To Our Valued Customers,

This PCN affects our iMX8M Mini uCOM board (product number: EAC00336 and EAC00349).

Below is a picture of the new rev B3 board.

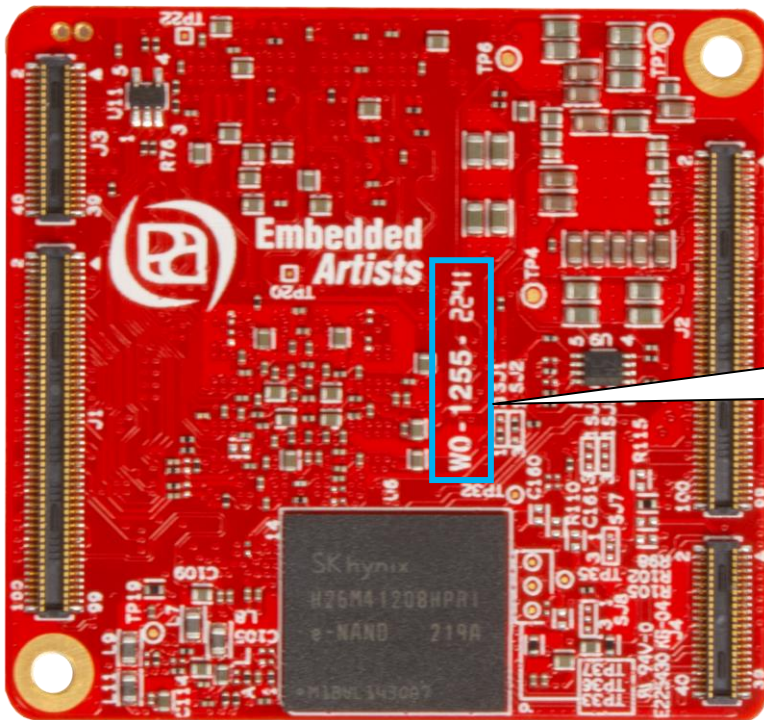
The Gigabit Ethernet Phy, AR8031 from Atheros, is not available on the market. We have replaced it with RTL8211FDI from Realtek. Although the update only has minimal software implications it is not 100% backward compatible.
The new replacement products are named EAC00432 (that matches the original EAC00349, i.e., extended temperature range) and EAC00437 (that matches the original EAC00336, i.e., commercial temperature range).

The new Ethernet-Phy will be mounted on boards produced after January 2023. All boards from Embedded Artists have a marking: WO-XXXX-YYWW, where XXXX is the WO-number. YY is the year and WW is the week number when the board was produced.

The affected boards will have a WO-number above or including: XXXX ≥ 1255.

Marking on top side. The board revision (rev B3 in this case).

Realtek logo on top side of the Ethernet-Phy.

Marking on bottom side. The WO-number is 1255 in this case.
